# 420 kV CAPACITOR VOLTAGE TRANSFORMER TYPE: CPB-H 420

**CHIEF ENGINEER  
PLANNING & POWER SYSTEMS  
APTRANSCO**

**LIST OF DOCUMENTS FOR CPB-H 420 TYPE CVT**

420 Kv Capacitor Voltage Transformer Type: CPB-H 420  
General Arrangement Drawing

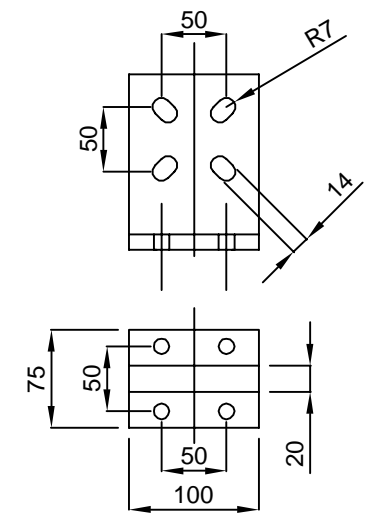
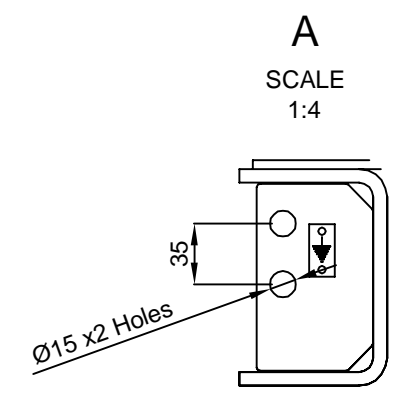
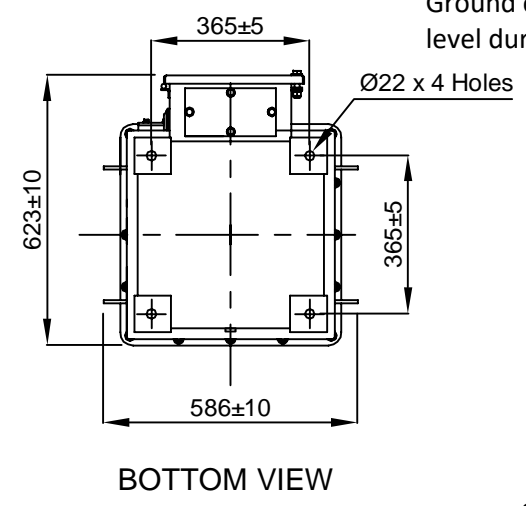
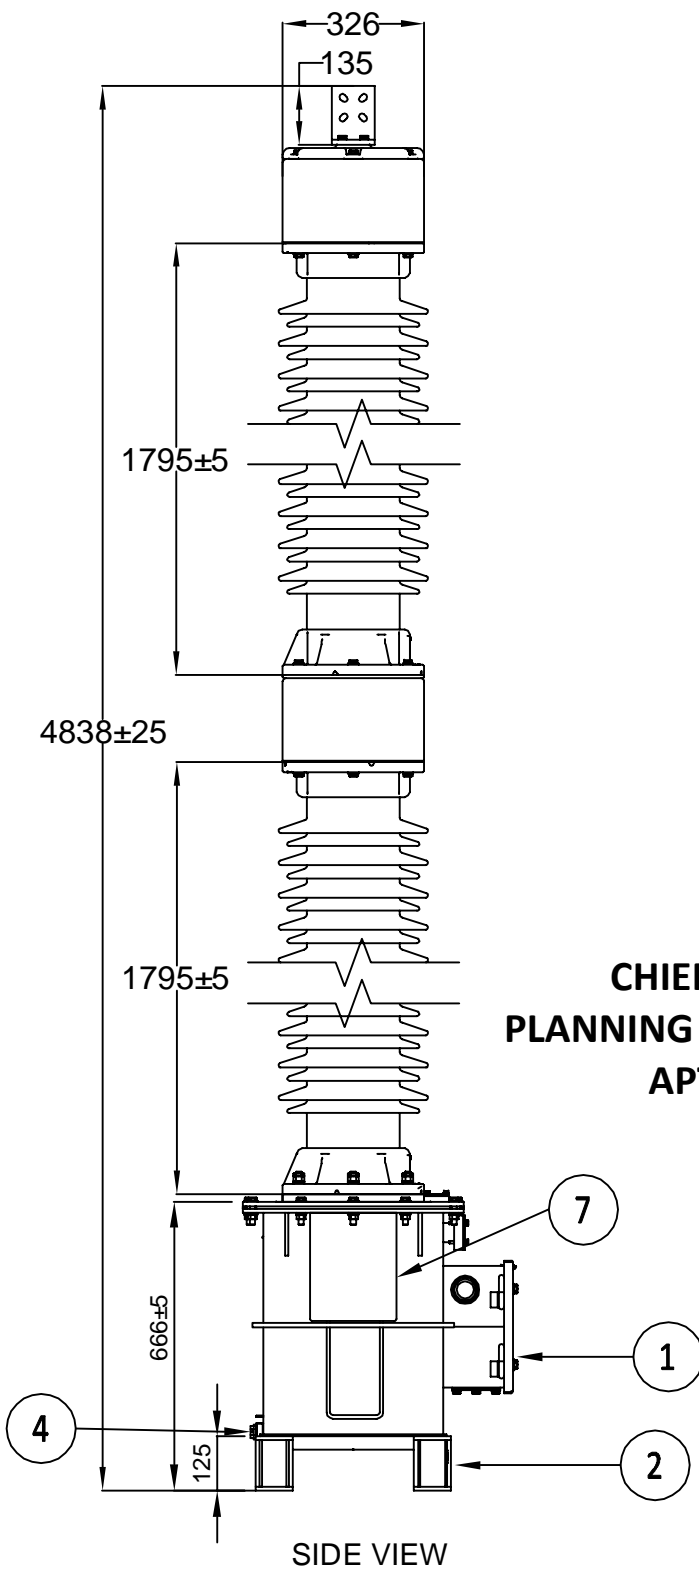
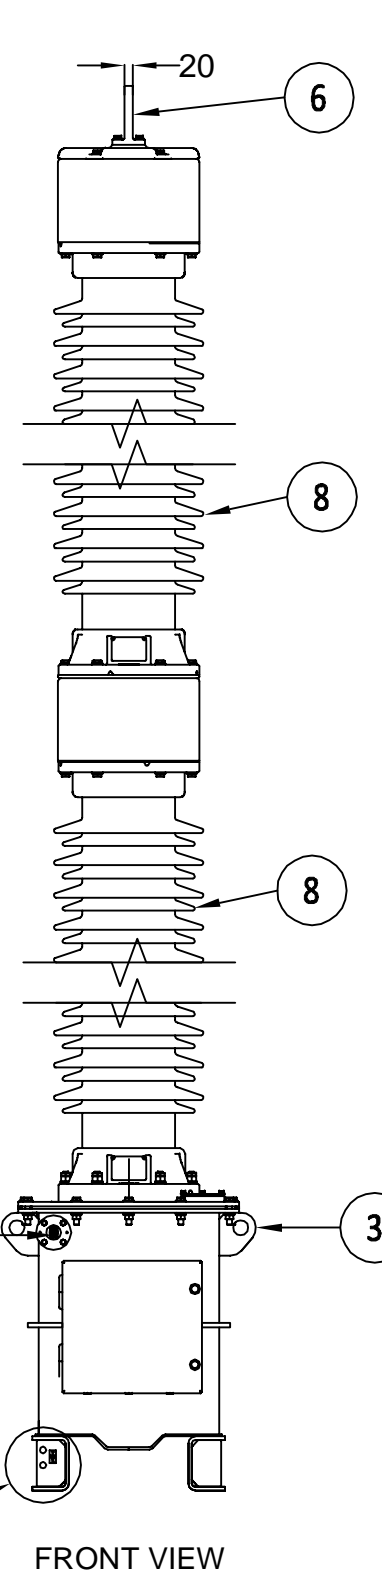
Ground clearance of 8000mm shall be maintained from plinth level during erection. SCALE 1:3

Since the supply of terminal connectors is not in the scope of Manufacturer as mentioned in the drawings The EPC contractor shall be instructed to supply the same in line with CT/PT/CVT/Isolator/VT/LA/Breakers, requirement and capability.

**Rating & Diagram Plate for  
420kV Capacitor Voltage  
Transformer**

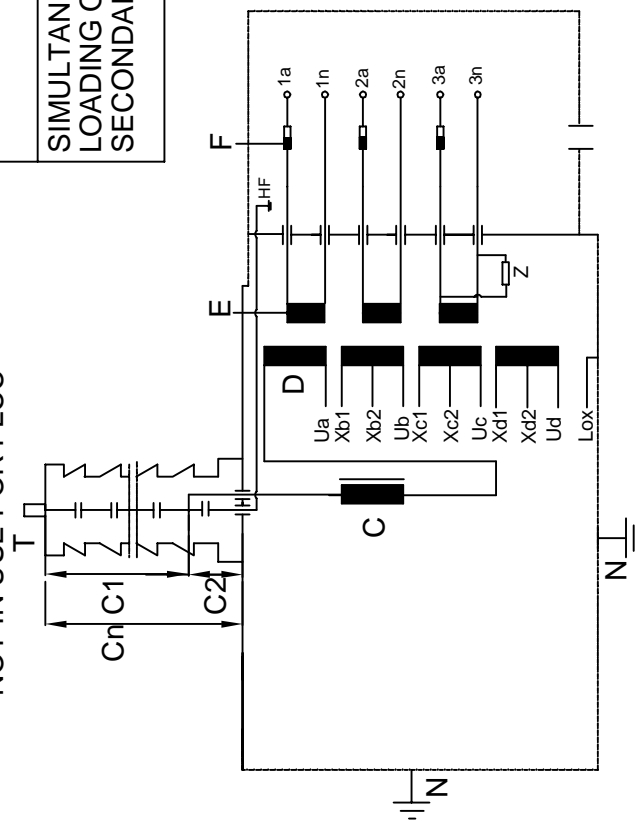
Ground clearance of 8000mm shall be maintained from plinth level during erection.

Since the supply of terminal connectors is not in the scope of Manufacturer as mentioned in the drawings The EPC contractor shall be instructed to supply the same in line with CT/PT/CVT/Isolator/VT/LA/Breakers, requirement and capability.

Revision		420 KV Capacitor Voltage Transformer Type: CPB-H 420	SECONDARY TERMINAL BOX	DRAWN: SR	CHECKED: SNP	APPRD.: SN	file: 3320-064	TOTAL SH. 1
A	2022-06-09			<b>ABB</b> HITACHI ENERGY INDIA LIMITED (FORMERLY KNOWN AS APPSIL)			1HYT903320-064	Sh. NO. 1
B	2022-06-29

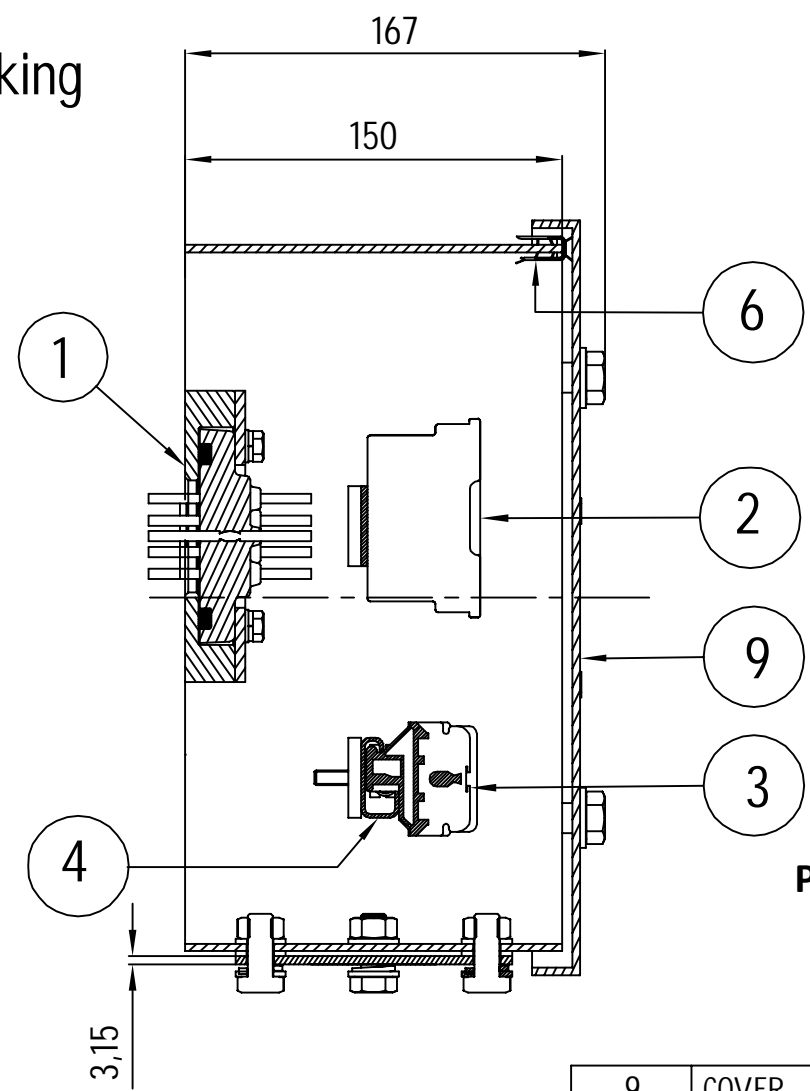
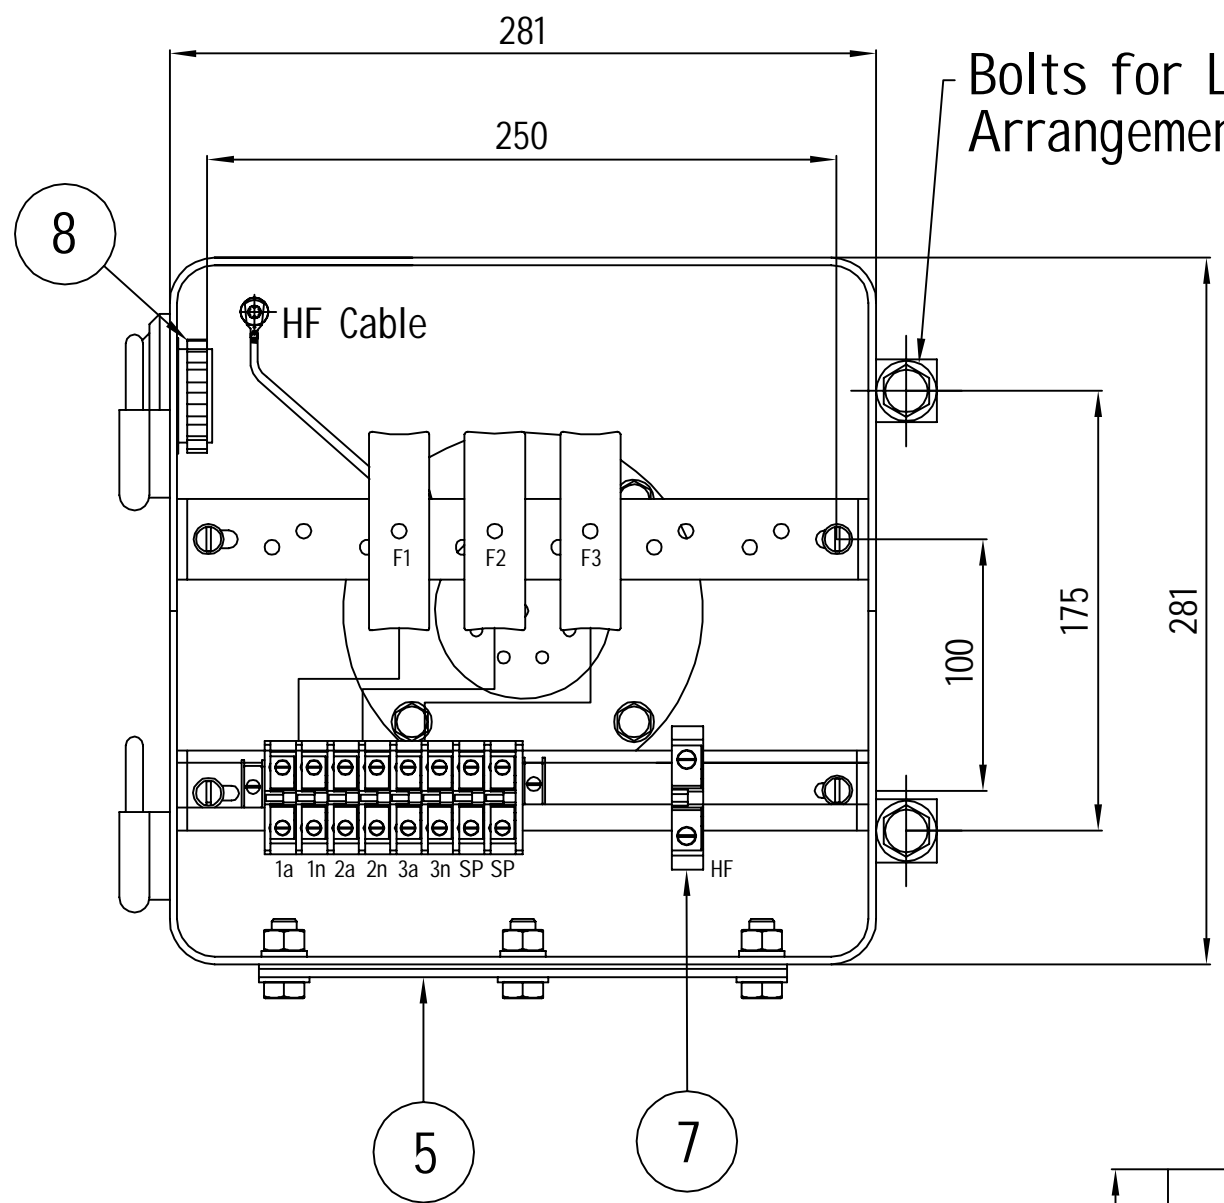
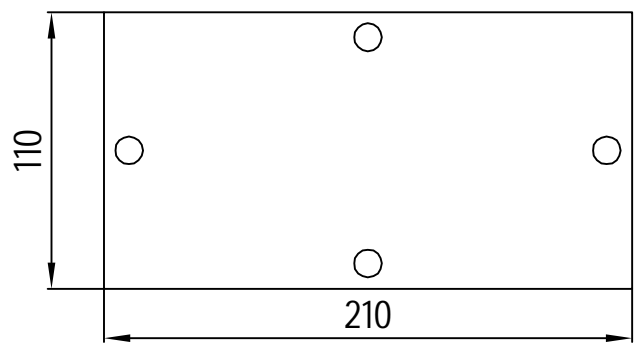
Ground clearance of 8000mm shall be maintained from plinth level during erection.

Since the supply of terminal connectors is not in the scope of Manufacturer as mentioned in the drawings The EPC contractor shall be instructed to supply the same in line with CT/PT/CVT/Isolator/VT/LA/Breakers, requirement and capability.

Revision		420 kV Capacitor Voltage Transformer Type: CPB-H 420	INSULATOR DRAWING (25 mm/kV)	DRAWN: SR	CHECKED: PDS	APPRD.: SN	file: - 3320-076	TOTAL SH. 1
A	2022-06-09			HITACHI ENERGY INDIA LIMITED (FORMERLY KNOWN AS APPSIL)			1HYT903320-076

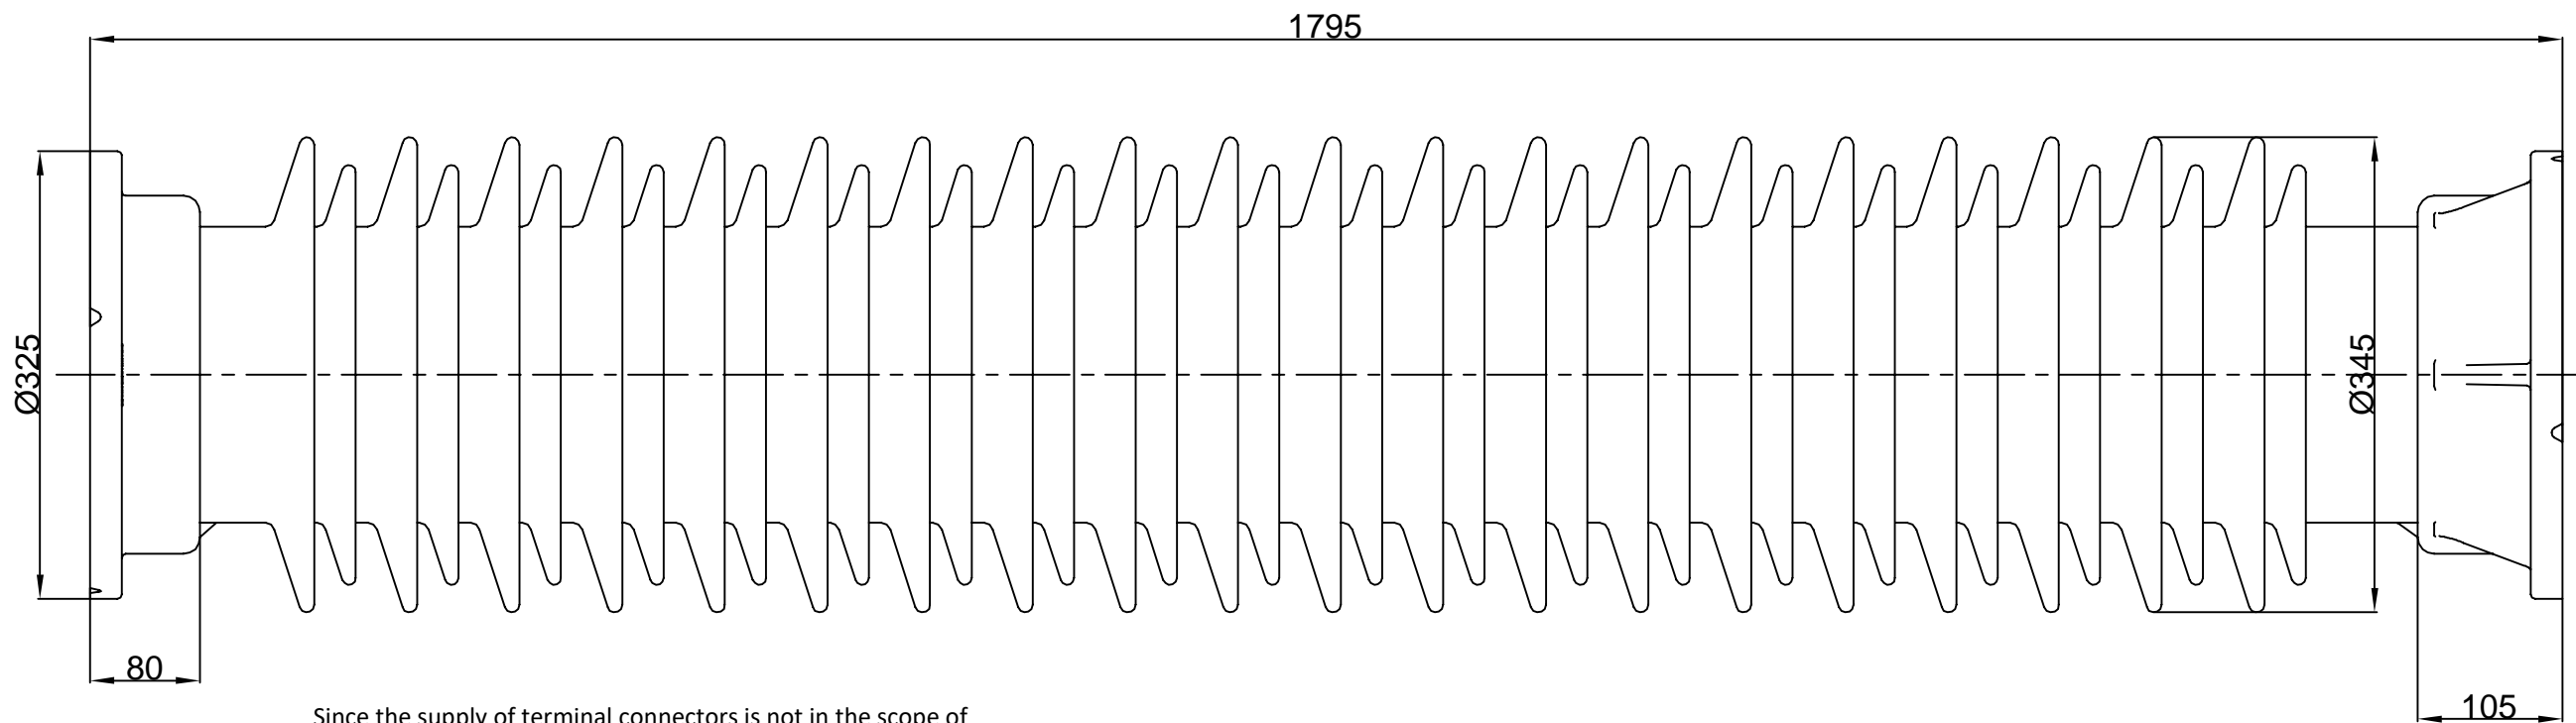
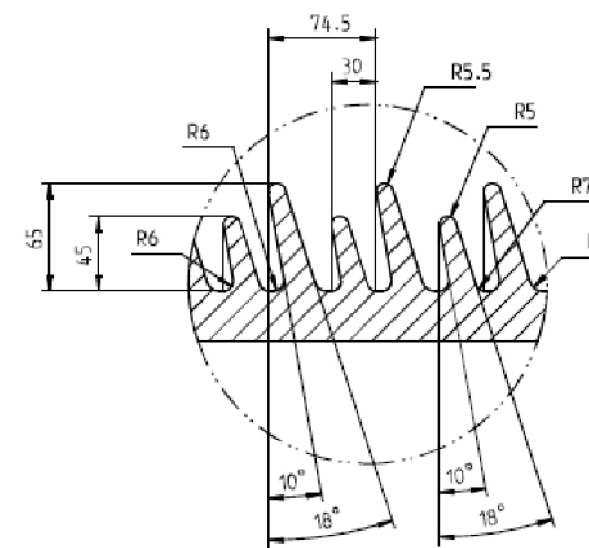
Ground clearance of 8000mm shall be maintained from plinth level during erection.

Since the supply of terminal connectors is not in the scope of Manufacturer as mentioned in the drawings The EPC contractor shall be instructed to supply the same in line with CT/PT/CVT/Isolator/VT/LA/Breakers, requirement and capability.
